BALDWIN HARBOR - LOTS 626 & 629 SPMP AMENDMENT

SUMMARY

Amendment of the Specific Parcel Master Plan (MPL2005-00036) for Lots 626 and 629 to construct two 4-story multi-family infill buildings with structured parking and amenities. Lot 626 is proposed to contain 227 residential units, and Lot 629 is proposed to contain 256 residential units, for a total of 483 residential units.

Staff's Recommendation:

**ZOM Baldwin Harbor - Parking Analysis
Parcel 626**

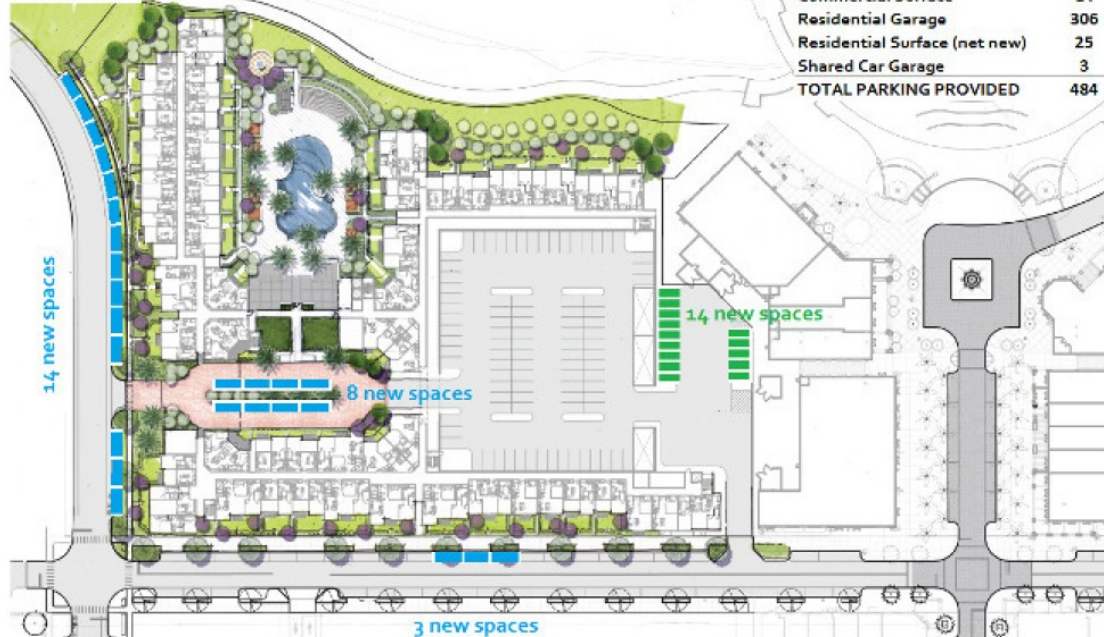
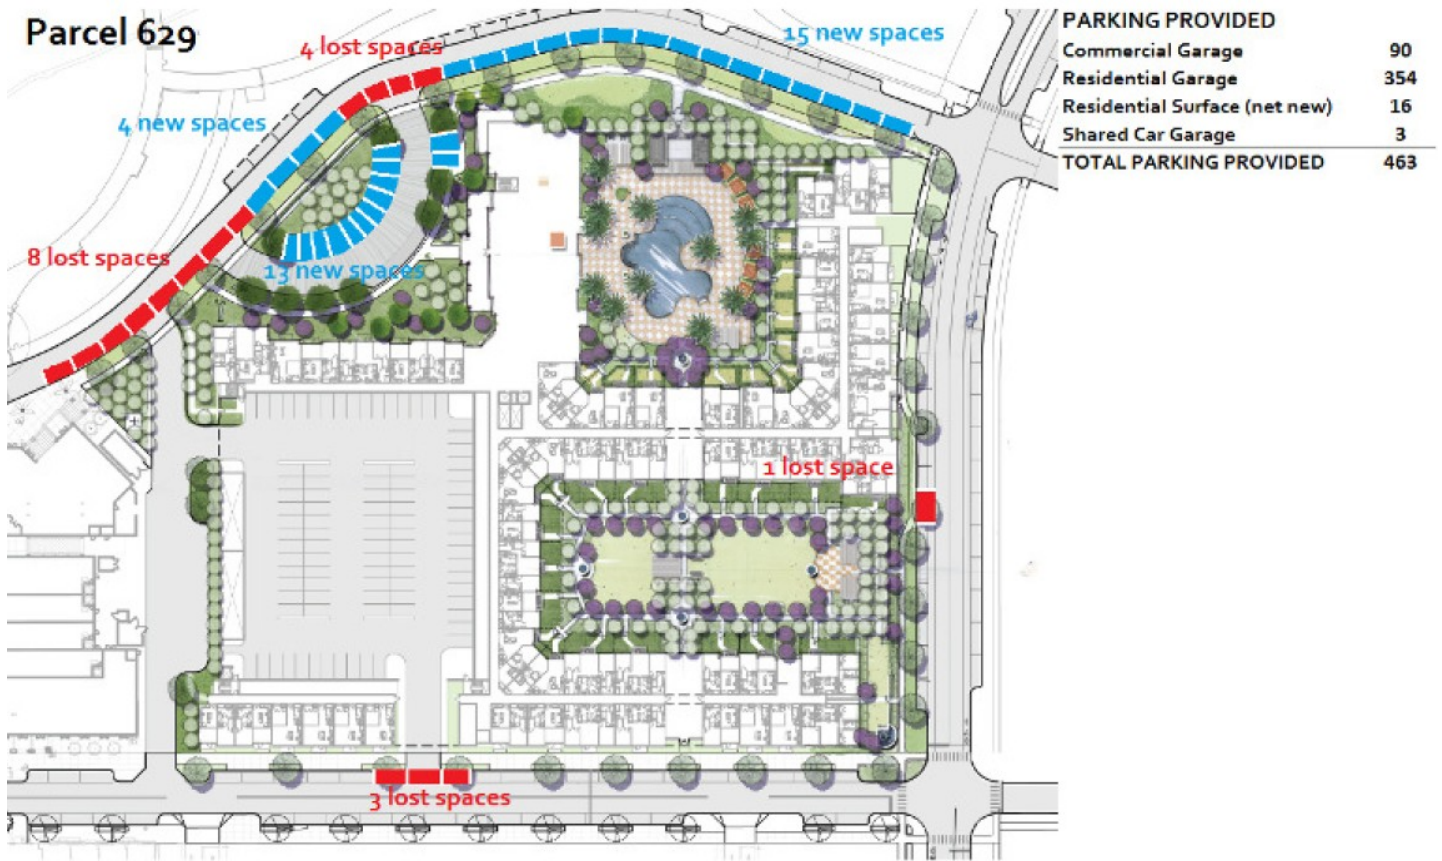
The proposed parking plan does show a reduction of 33 residential spaces in comparison to the Land Development Code guideline. However, the analysis and parking spaces per unit type that the applicant is providing is consistent with other residential projects that have been approved in Baldwin Park, such as the most recent project, The Jefferson (currently named the Azul) located at 4500 Lower Park Road (MPL2012-00002). The Jefferson project also included new and existing on-street parking spaces toward their required parking counts. In the Baldwin Harbor analysis, the existing on street parking spaces that are not being altered (approximately 49), are not included in their total parking count. Staff’s analysis of the proximity and number of spaces existing directly adjacent to each lot has determined that the total number of spaces that could be utilized for both the existing commercial and neighboring residential, as well as those spaces provided within the parking garages and on-site, is consistent with the principals of the Baldwin Park PD.

- B. The surface parking lot between the commercial building and Lot 626 shall be revised to remove the parking spaces that are located directly in line with the pedestrian breezeway connection. The Pedestrian connection shall be continued to connect to the parking garage.

DEVELOPMENT PLAN

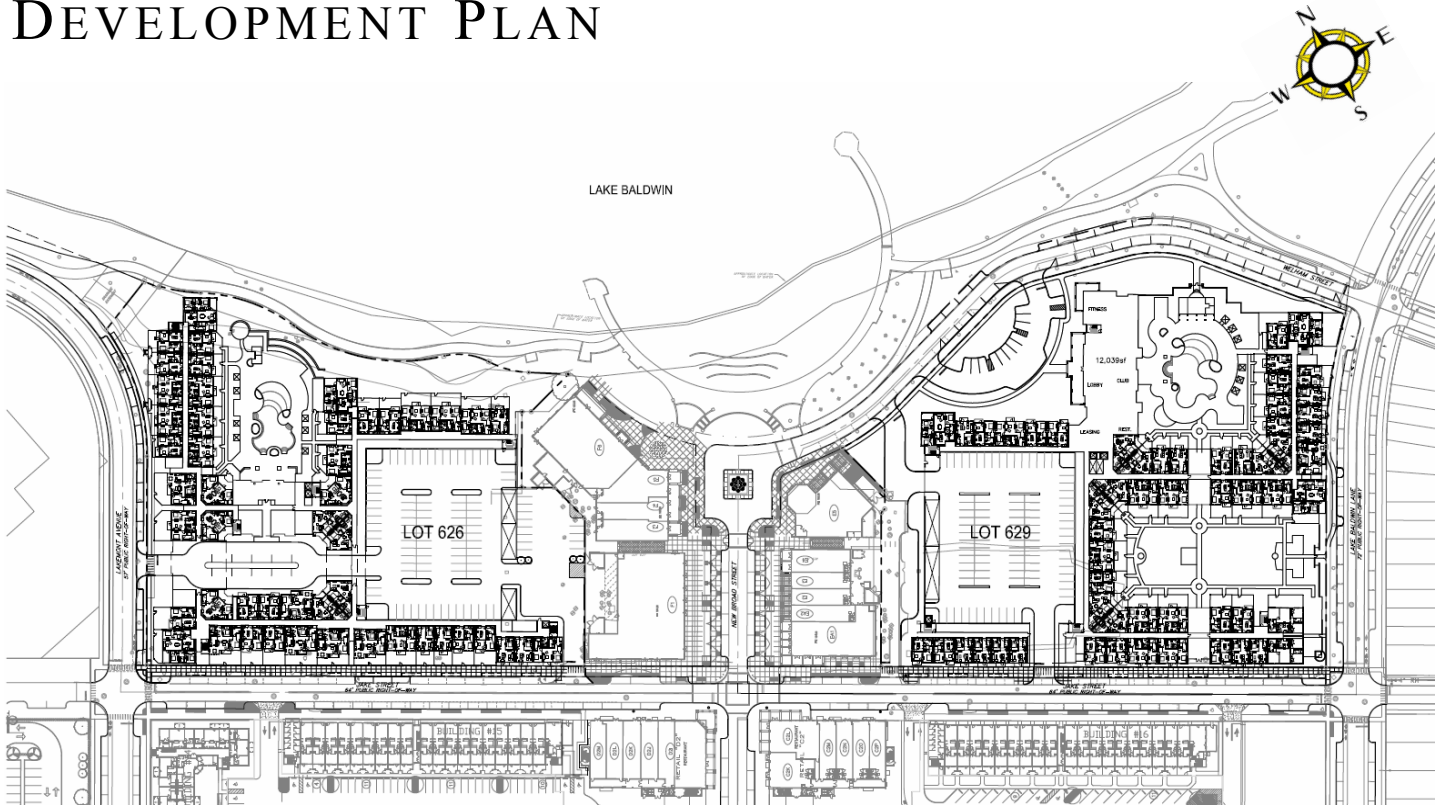
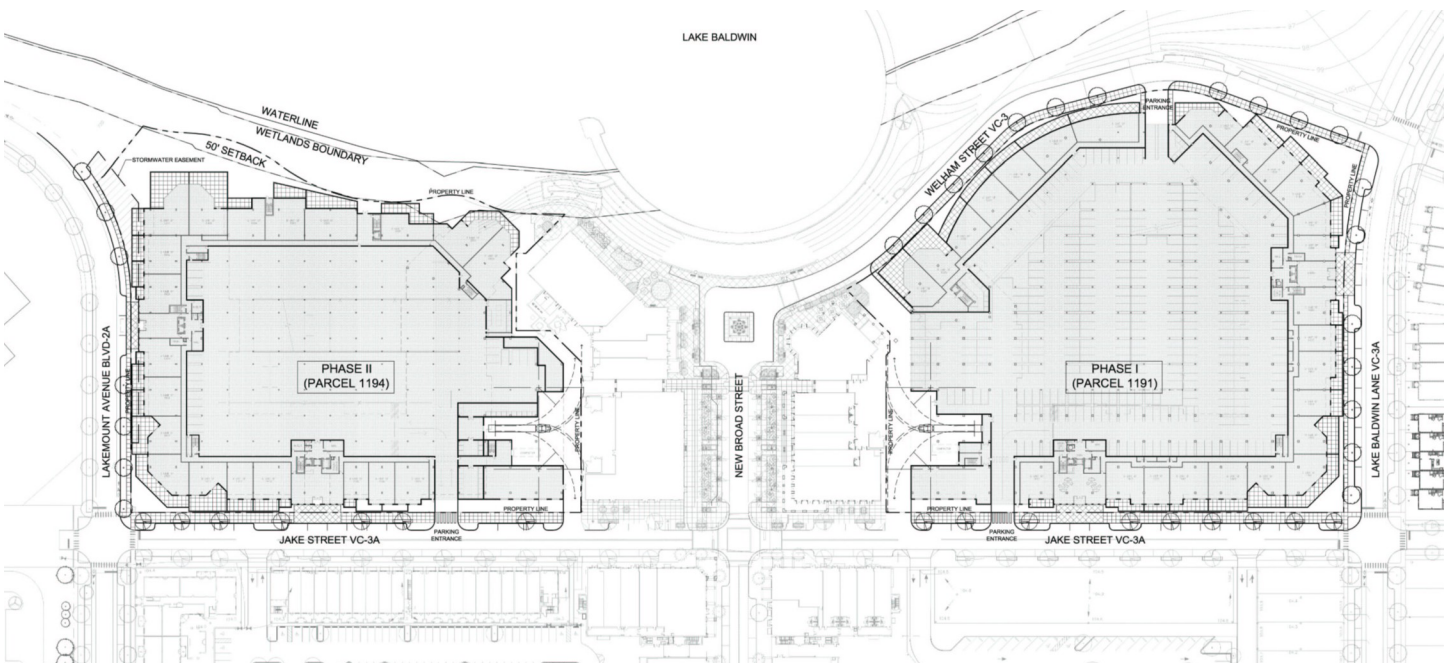
The revised development plan as submitted with this application.

The approved development plan as reviewed by BP TDR on August 25, 2005. This plan incorporated two buildings ranging from 7 -8 stories in height.
